NOTICE OF APPEAL

Re: Bardis Project (PLN140715-AMD1)
Our File: 34238.32387

RE: Bardis Residence Coastal Development Permit Application – Entry/Parking Area proposed modifications

Reference: Bardis Motor Court Project
PLN140715-AMD-1
APN 008-341-026
1525 Riata Road
Pebble Beach, California

A. The motor court is shown in this drawing in front of the main entrance to the residence.

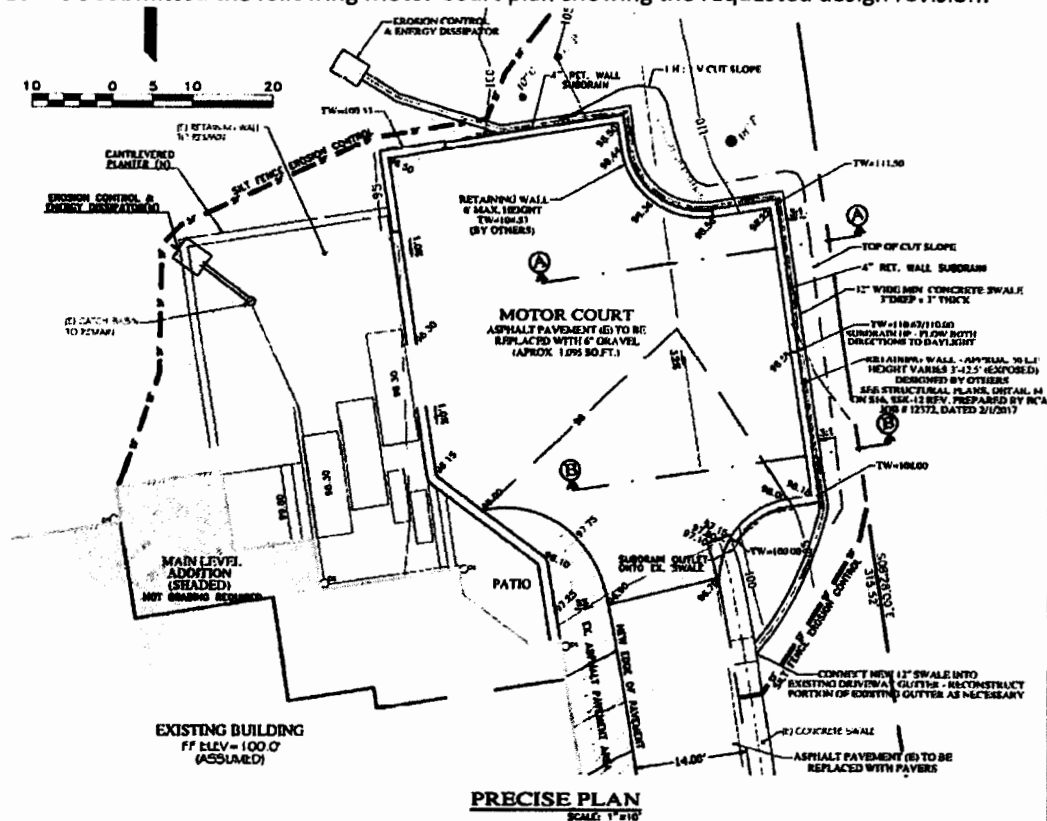
The Bardis's request is to relocate parking and turnaround areas from its original approved location at the front entrance, to a location on the east side of the driveway. The original (and approved) layout, as shown on sheet C1 of the approved civil drawings, dated revised 1/17/13, is shown below:

Yes. The driveway and parking area originally approved were adequate for ADA. The area would have had only minimal slopes for drainage (1%), thus complying with requirements for an essentially level parking area and path of access. In addition, the parking located adjacent to the entrance would allow access without having to cross a vehicular lane. However, the original approved design included steps from the parking area to the house, thus interrupting the path of access. There is no proposed change to that element, meaning that the proposed design would still not meet ADA requirements.

The original design, as shown in image 'A' above, shows accommodation in the motor court for accessible parking and a short access path. As shown in 'B', with the new landscape entry area, accessibility is not as well addressed, requiring a longer path conflicting with vehicular movements. The most appropriate way to address the owner requirement is to adhere to the approved design.

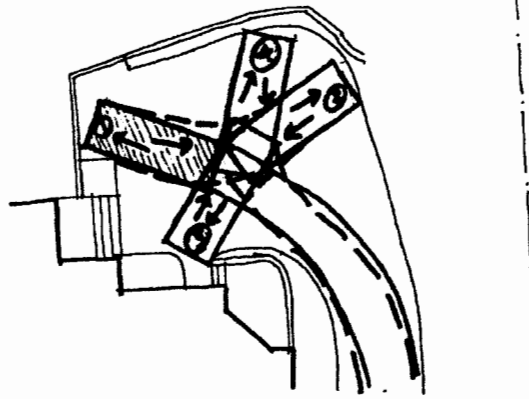
No. The original layout with parking located adjacent to the entrance would allow access for persons with disabilities without having to cross a vehicular lane. The design revision proposed in the application would locate the parking on the opposite side of the driveway - requiring a much longer path of access, crossing the vehicle traffic lane, thus creating a safety hazard not created in the original configuration. In addition, the introduction of a wall bifurcating the motor court limits the turnaround area to the same extent as the parking area on the east side increases it (see turnaround pattern sketches below). This photo shows the already-constructed wall:

Turnaround pattern – approved design (5-point turn)

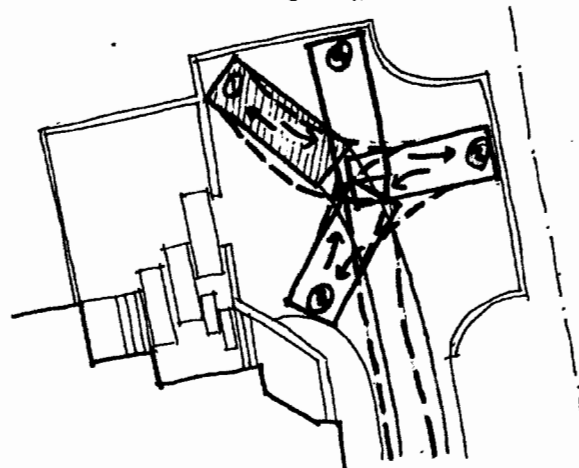
In the LUAC committee meeting last week, it was discussed that the original design failed to provide emergency vehicle access and turnaround, stating that a 6-point turn would be required. The drawing below shows my calculation that a 5-point turn would be required:

The applicant's claim that the original approved design fails to meet turnaround standards appears to be accurate in concept.

Turnaround pattern – requested design revision (5-point turn)

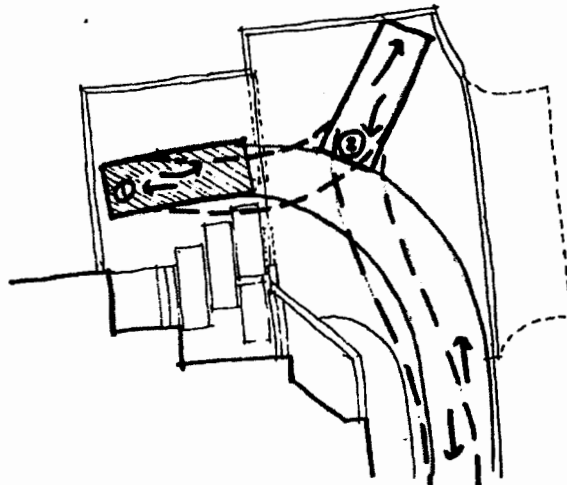
The turnaround pattern as applied to the proposed revised layout, with deletion of the parking area adjacent to the entry steps on the west side, and replacement with a parking area on the east side of the driveway (in the 20-foot setback area with retaining wall), shows the following pattern:

The revised design appears to have the same 5-point turn, the same as the original design.

GRADING, DRAINAGE & EROSION CONTROL PLAN
BARDIS RESIDENCE
 A.P.N.: 008-341-0226
 PINEHILL BRANCH, MONTGOMERY COUNTY, CALIFORNIA

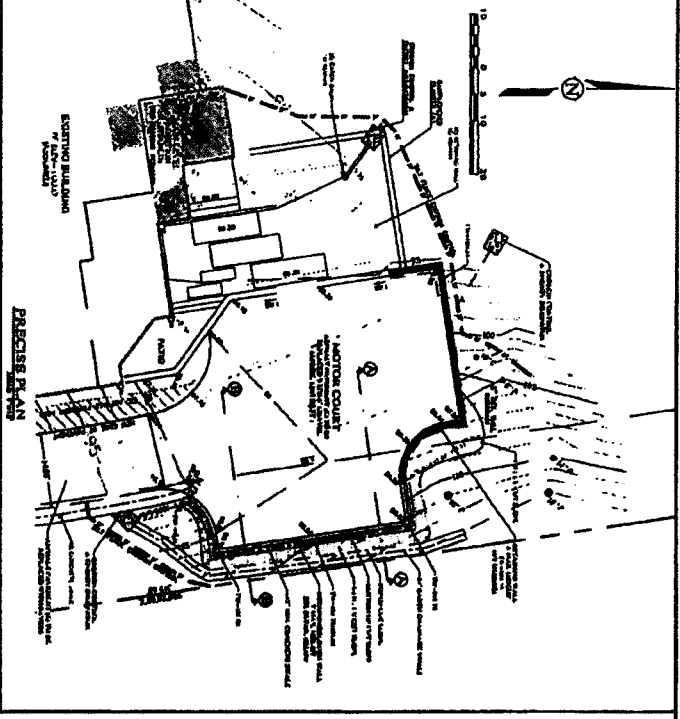
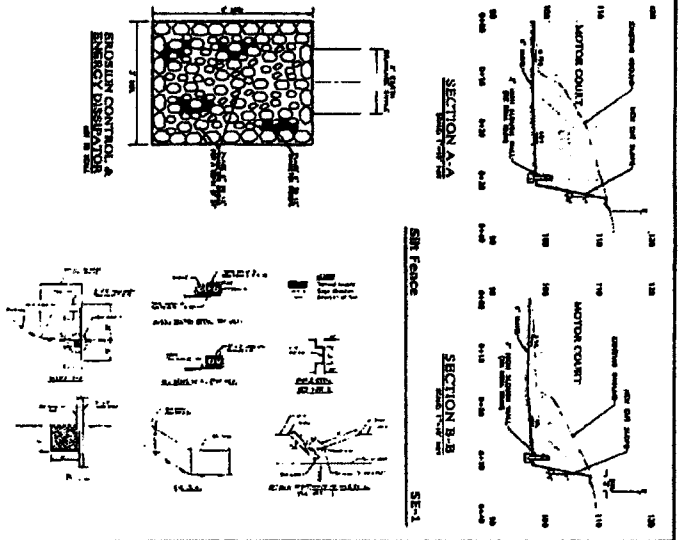
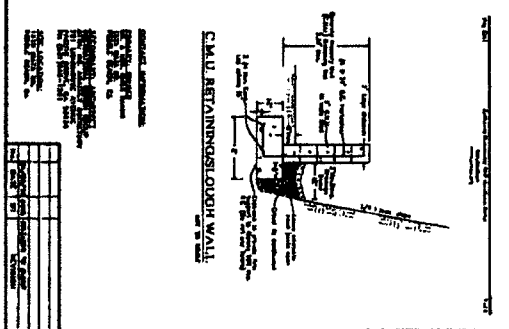
¹ The project would involve approximately 300 cubic yards of material, not just 15 as the staff report suggests; see original plan (Exhibit D) showing the cut materials and thus enabling this calculation; note: this detail was conveniently deleted from later plan iterations including the one attached to the staff report. See also original application (Exhibit E).

Cross Sections A-A and B-B on the grading plan indicate a 36 foot long portion of the existing driveway on the Bardis property will be widened to create the proposed motor court by excavating 15 feet into the hillside on the south end and 23 feet into the hillside on the north end. The excavations will leave a 9.8 foot high to 13.7 foot high unsupported cut with very steep $\frac{1}{4}$:1 gradients. At the base of the cut slope,

May 7, 2015 drawing – application on Acela July 8, 2015.

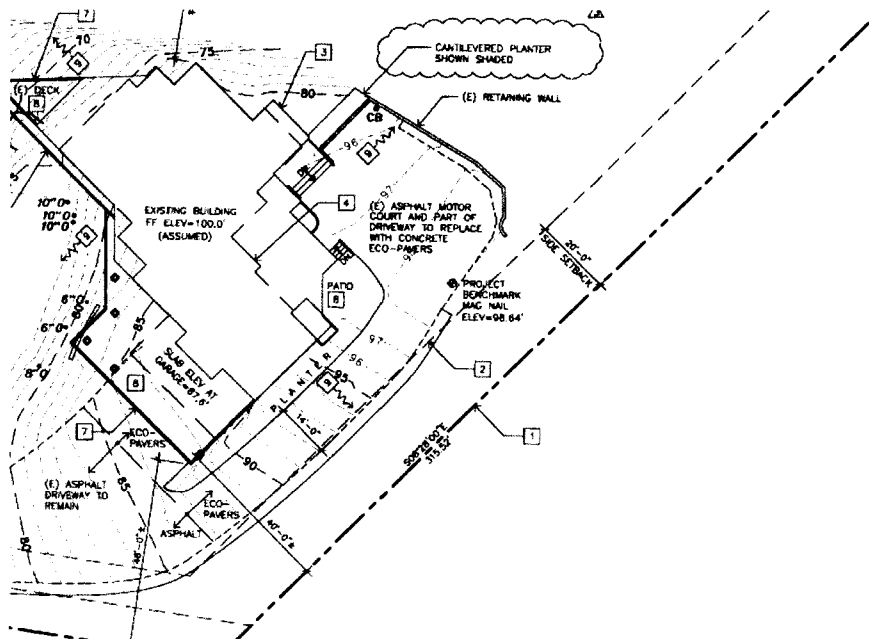
1. Was the courtyard wall dividing the motor court from the newly proposed landscape area part of the May 2015 plan referred to by the planner during the April 26 Planning Commission hearing?

No. The May 7, 2015 drawing shows the enlargement of the motor court by cantilevering the edge of the court beyond the existing retaining wall. This drawing shows on Acela as approved on July 8, 2015.

September 2015 drawing.

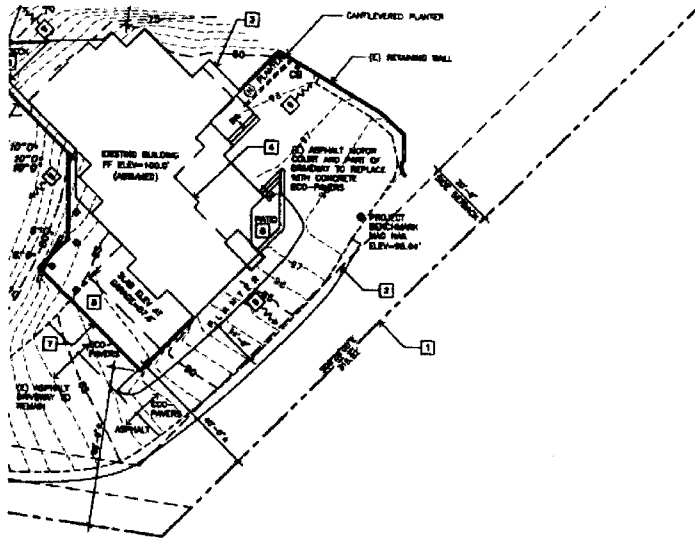
The September 2015 drawing still shows only the cantilevered planter.

Neither of those earlier drawings shows a wall dividing the motor court from the courtyard/landscape area.

February 2016 Drawing

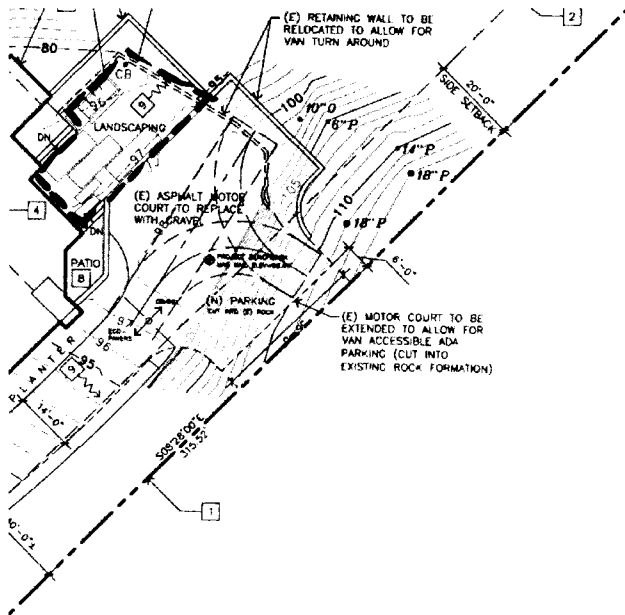
The February 29, 2016 (PLN140715-AMD1) drawing that first shows the landscape elements plus the wall (and adds the cut into the hill for the replacement parking/turnaround area) was not approved until the April 26, 2017 Planning Commission hearing.

Plan detail showing change from asphalt to eco-pavers.

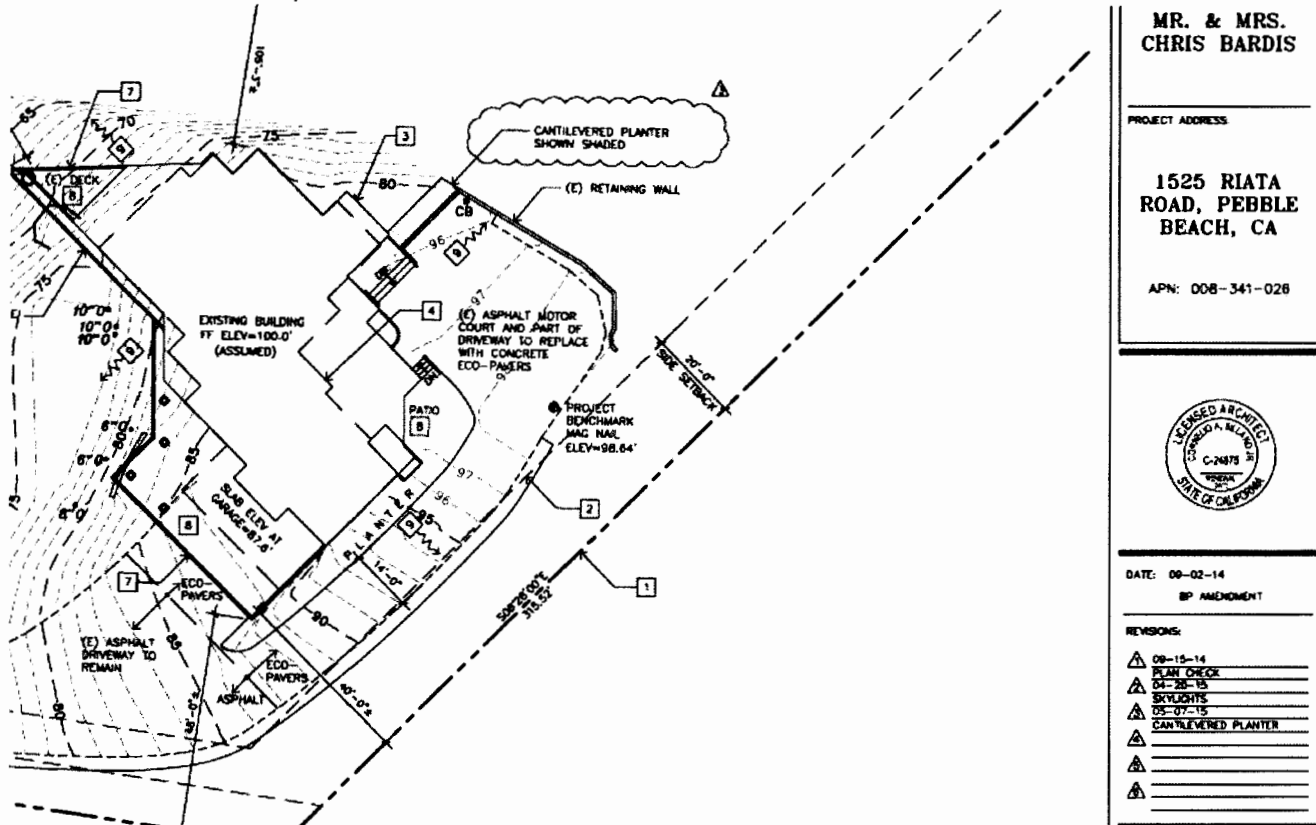
- a. The motor court and driveway were already designated for conversion from asphalt paving to eco-pavers, per the plans for PLN 120663 in June of 2014 (see plan detail below), and therefore cannot be counted again as a reduction. (Salmon colored area 'A' in sketch below).

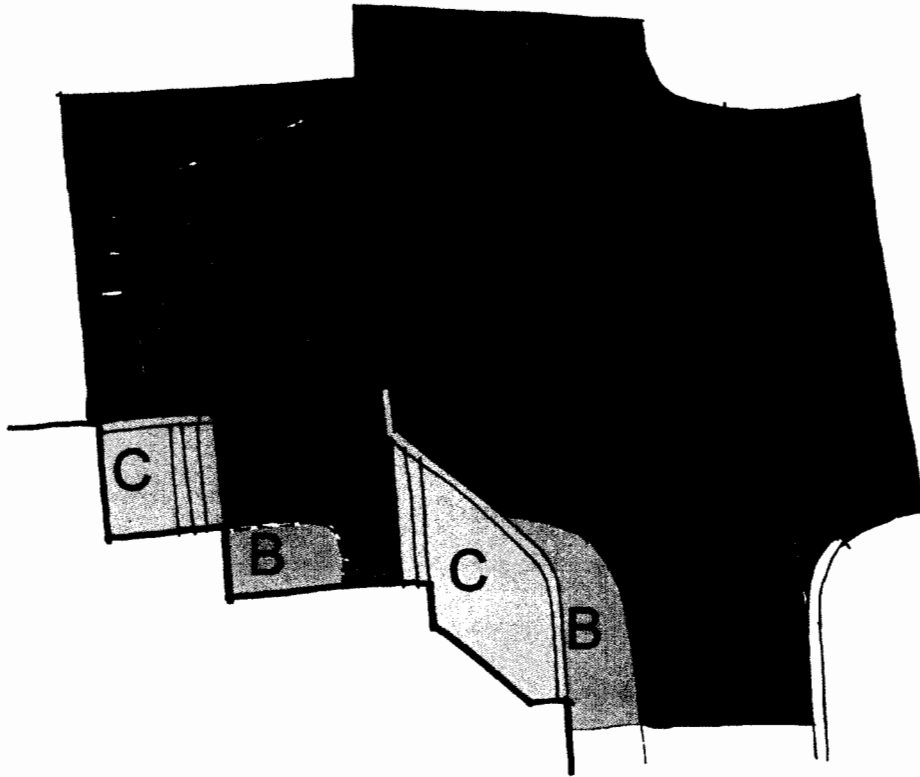
The sketch below shows the changes of coverage of the motor court, landscaped entry area, and hillside converted to DG parking with a retaining wall. Note that areas shown are conceptual and for comparison purposes.

- A. **Existing motor court** area already required to be permeable eco-pavers. Should not be considered as a reduction in coverage.
- B. **Existing landscape area** that remains as landscape area. Not included in measurements.

- C. Existing concrete entry steps, landing, and patio – no change from approved design. Not included in measurements.
- D. **Motor court area** converted from eco-pavers to courtyard/landscaping. Should not be considered as a reduction in coverage.

- E. **New stone** or concrete hardscape elements. These replace currently-required eco-pavers with non-permeable surfaces. Increase impervious coverage 205 square feet.
